REV 2	LANDSCAPING REVISED AS WELL AS LANDSCAPE AREA CALCULATIONS UPDATED	MAR. 16, 2022
REV 1	ISSUED FOR SITE PLAN APPROVAL	JAN. 27, 2022

SITE PLAN / LANDSCAPE PLAN

Project:
The "JAMES ST"
Apartment
157, 159 James St.
Ottawa, ON, K1R 5M4
Lot 21 & Part Lot 20, RP 30671

Dwg. Title:
SITE PLAN

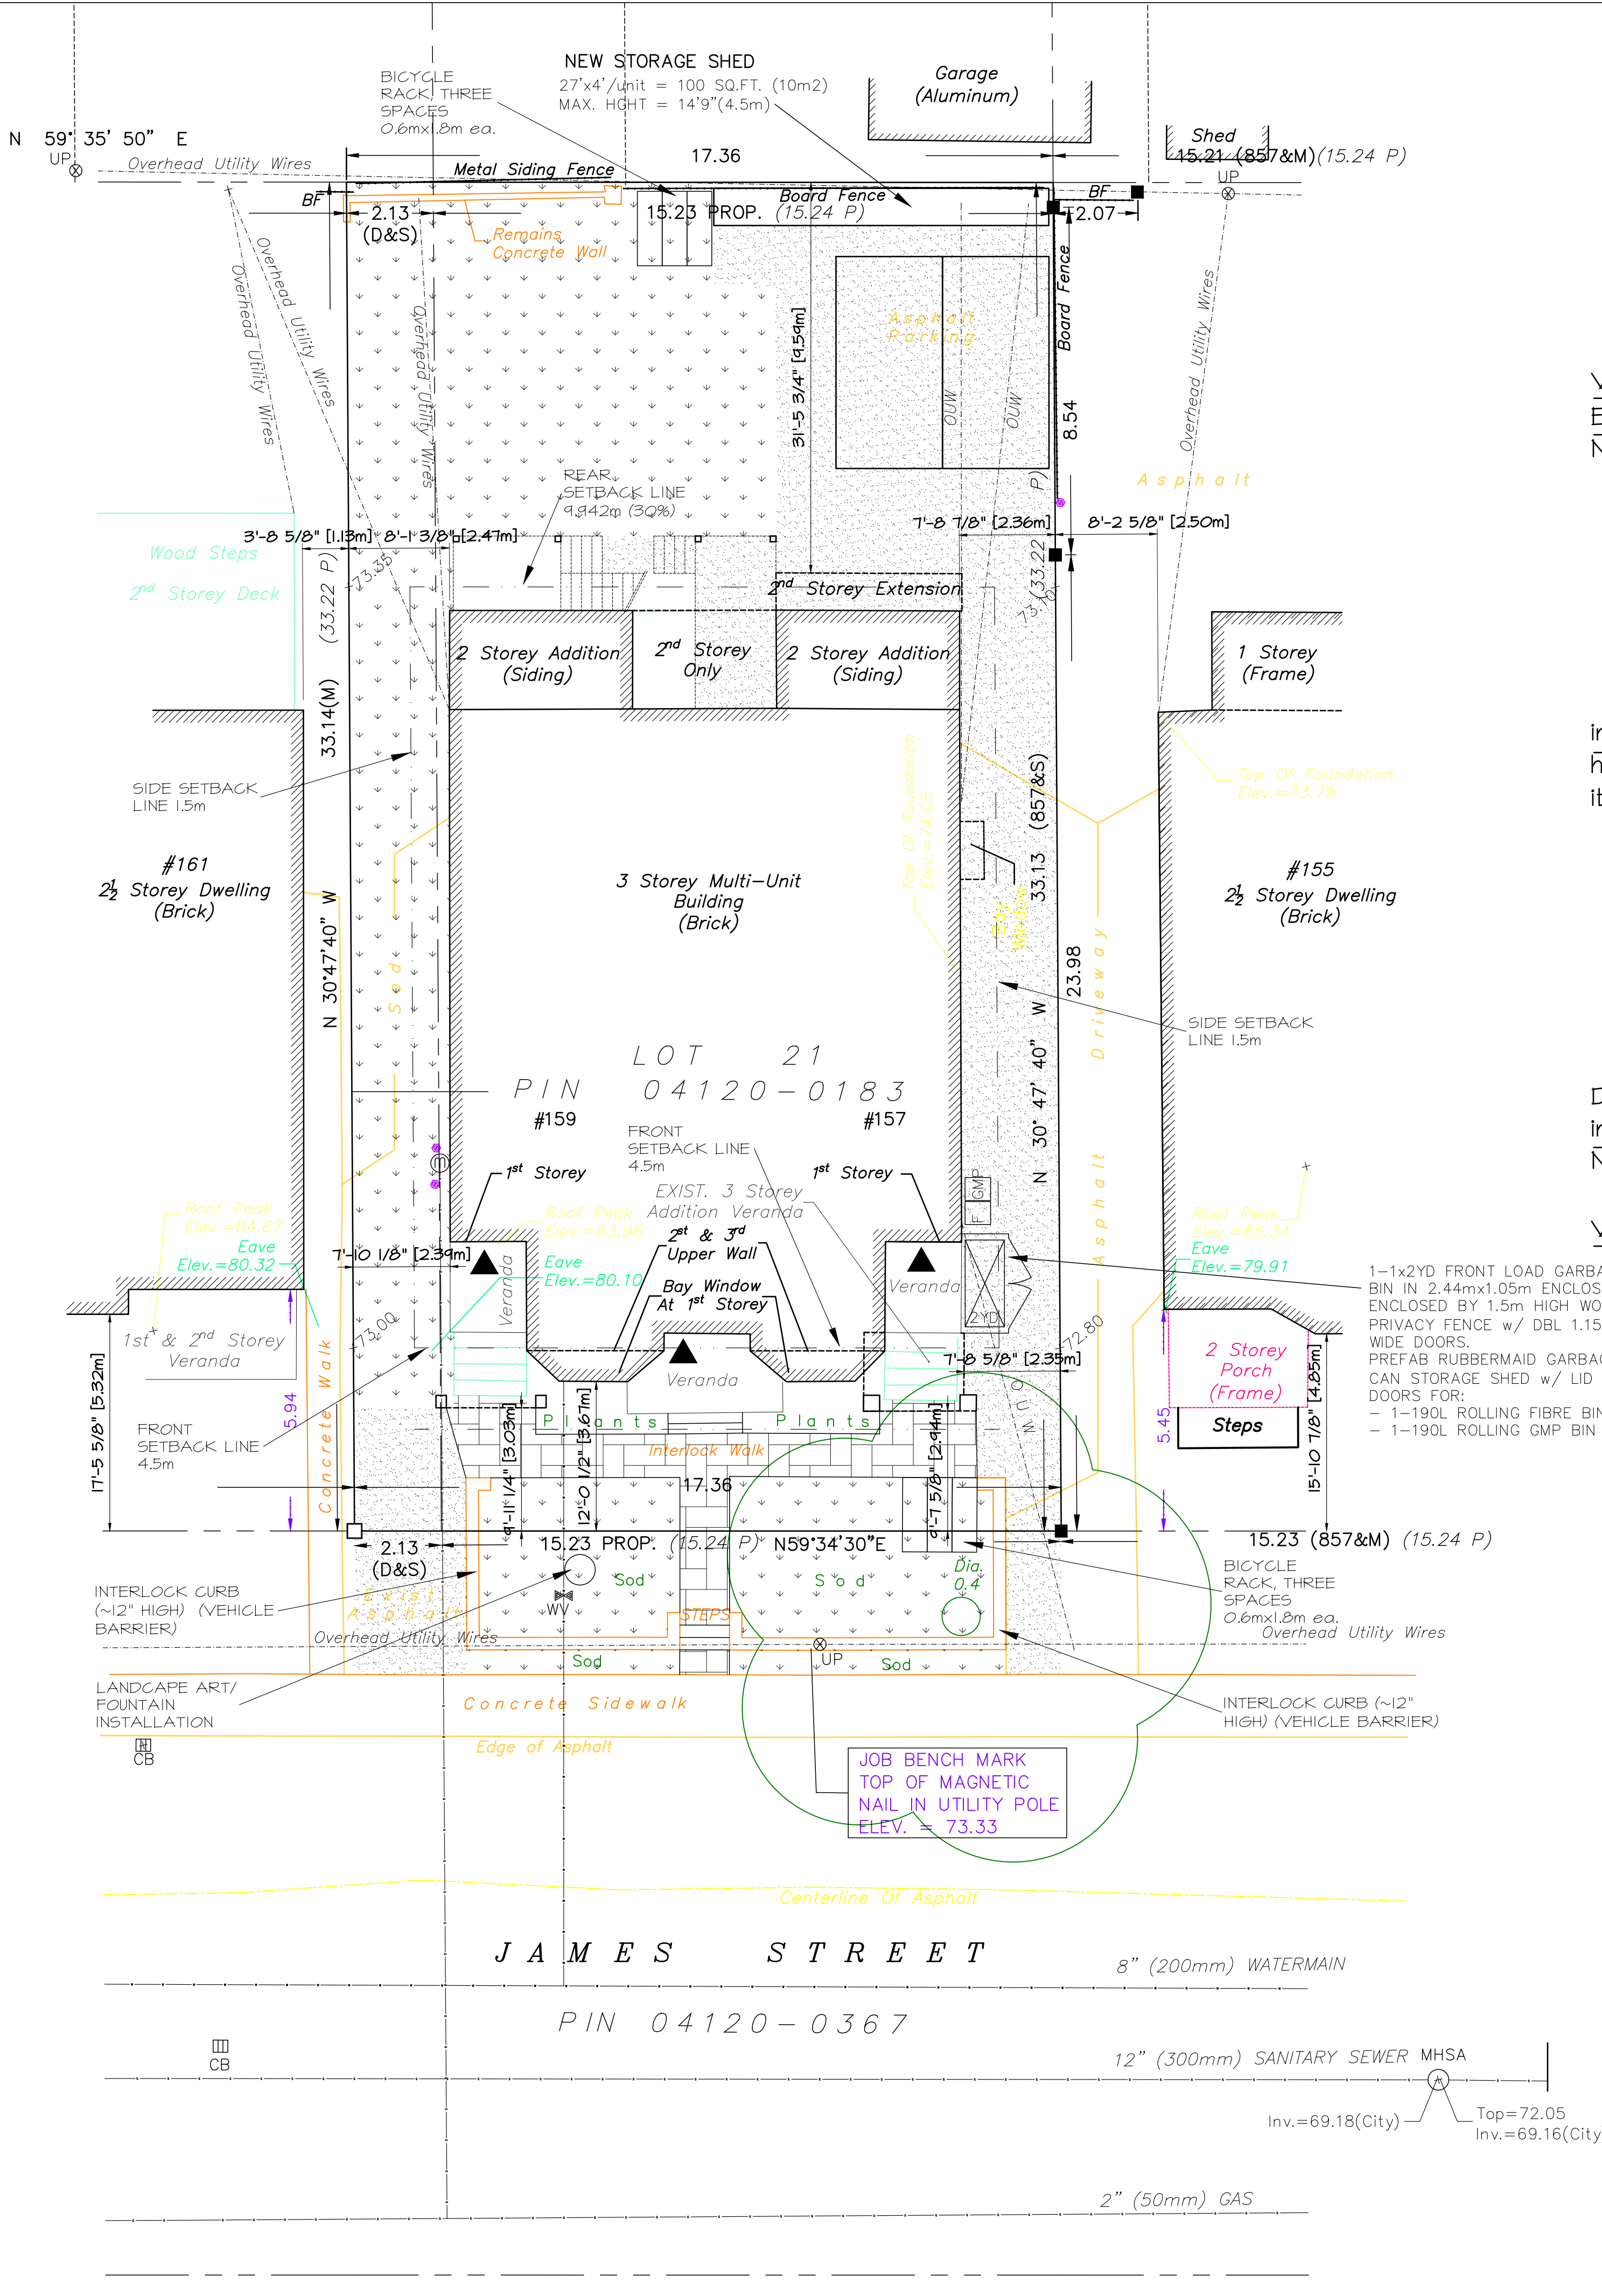
VARIANCE REQ'D
Existing
Non-Conformance

interpretation req'd
however at 6m2/unit
it is achievable

Depends on
interpretation -
No Variance req'd

VARIANCE REQ'D
